Product part number: SLG46200

Active SLG46200 Errata List

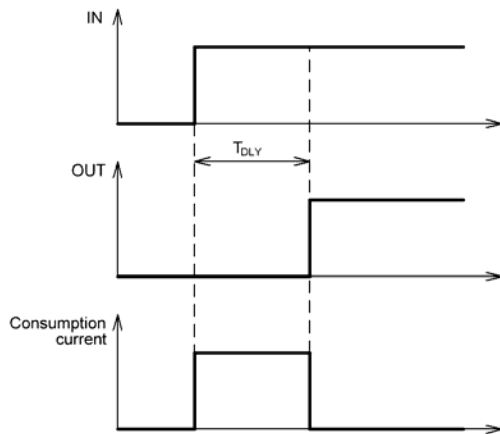
2. ADC PGA 0.5X gain accuracy

According to the datasheet and specifications ADC PGA has 0.5X gain. However, tested silicon has a measured value of 0.47X.

Use more accurate external voltage dividers.
If the ADC is used with DCMPs, error can be compensated by adjusting the DCMP register numbers.

Normal Delay block (rising edge) functionality

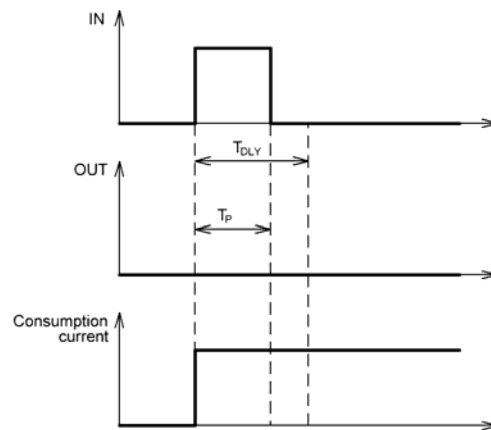
3. Delay blocks current consumption halt

If the delay input pulse duration is less than the delay time (other blocks do not use internal RC oscillator), the output will be correct but the power consumption will stay high. This is due to the delay block that starts RC OSC work after detecting a corresponding edge and then shuts it down after the delay time has passed. If the input signal duration (T_P) is less than the delay time (T_{DLY}), then the RC OSC won't shut down (delay cell will not give the RC OSC shut down signal internally) and the power consumption will go on. If any other delay cell or other block that uses OSC gives a shut-down signal then current consumption will stop.

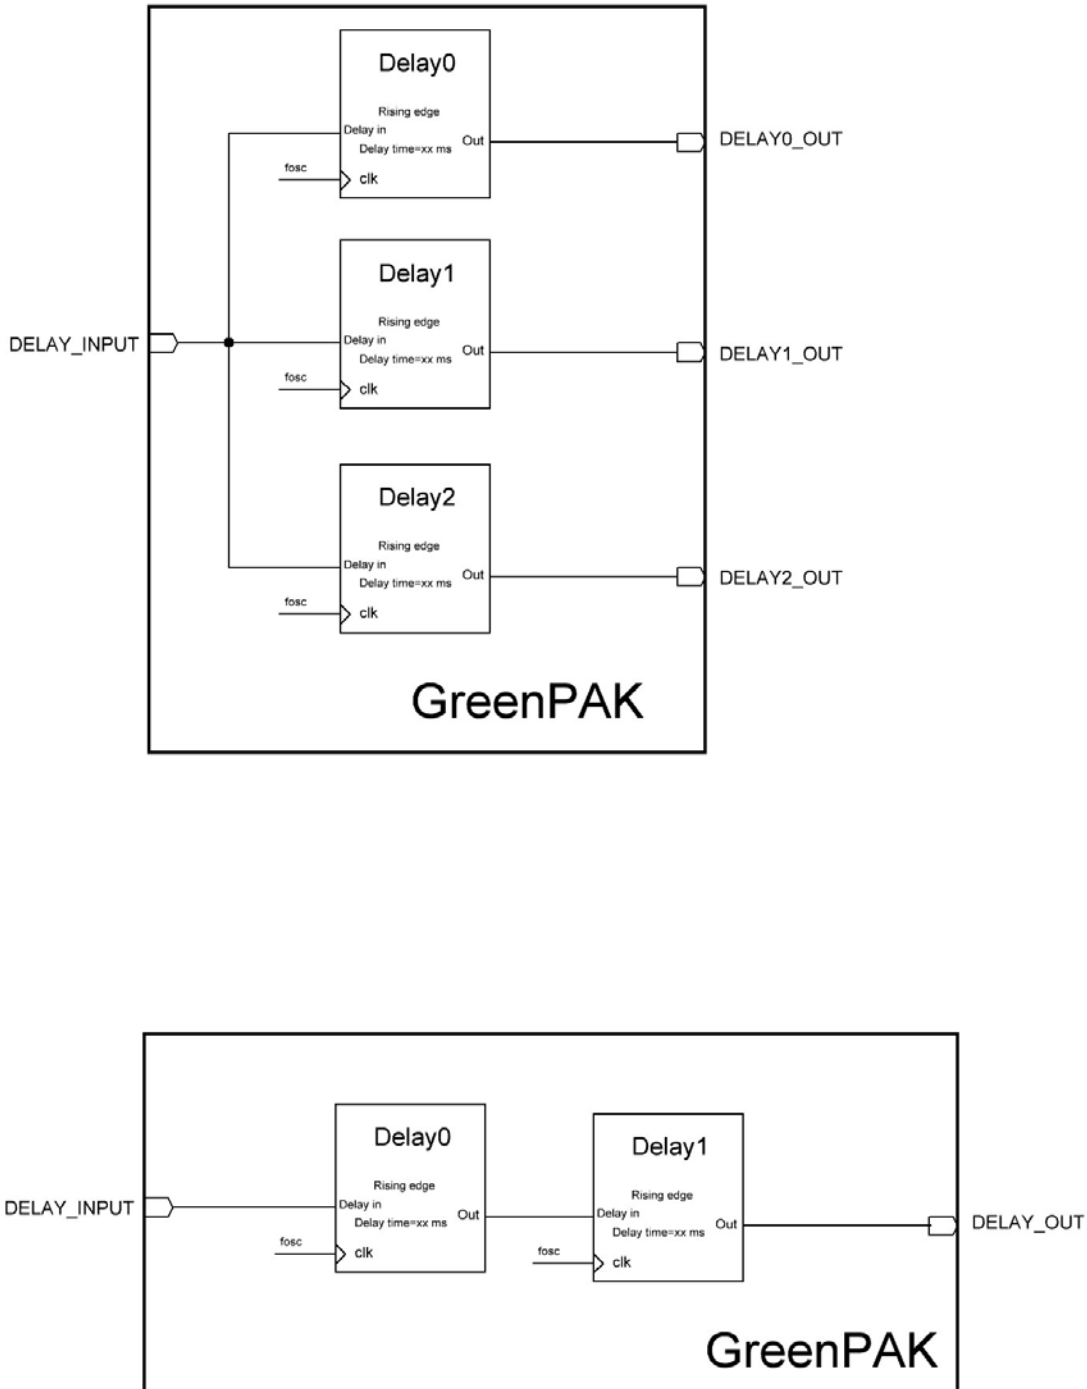
4. Delay blocks passing input signals to the output

If time between two detected edges is approximately two times less than the delay clock period, then the input signal may pass to the delay output.

As an example the rising edge delay cell test results with internal RC oscillator frequency 43kHz are shown below.

Use two Delay blocks in the series connection.

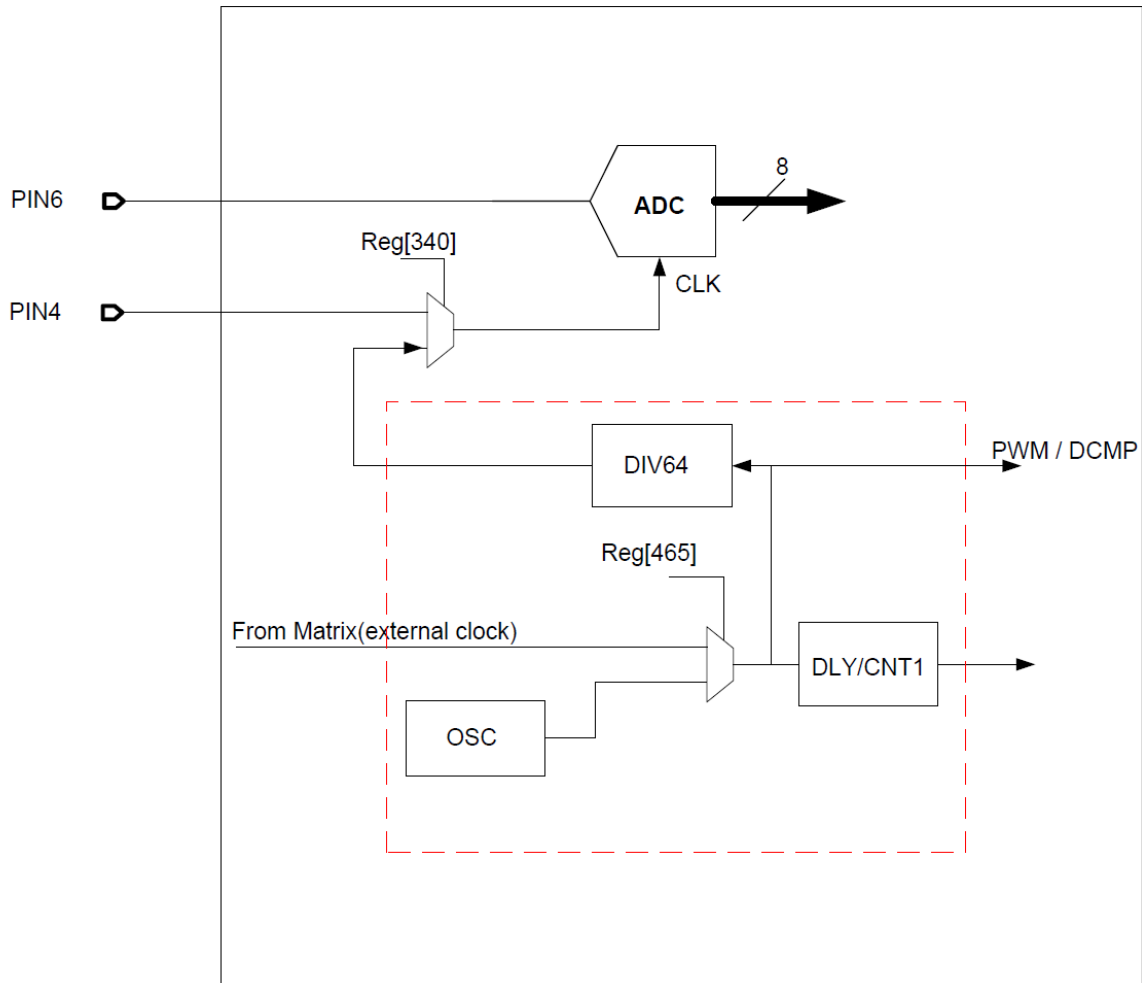
5. Analog-to-Digital Converter (ADC) using the Counter 1 clock.

The ADC uses Counter/Delay 1 clock source for sampling data. So if the Counter/Delay 1 clock is not connected, the ADC will not function at all.

Use the internal clock for Counter/Delay 1 for correct ADC functionality.
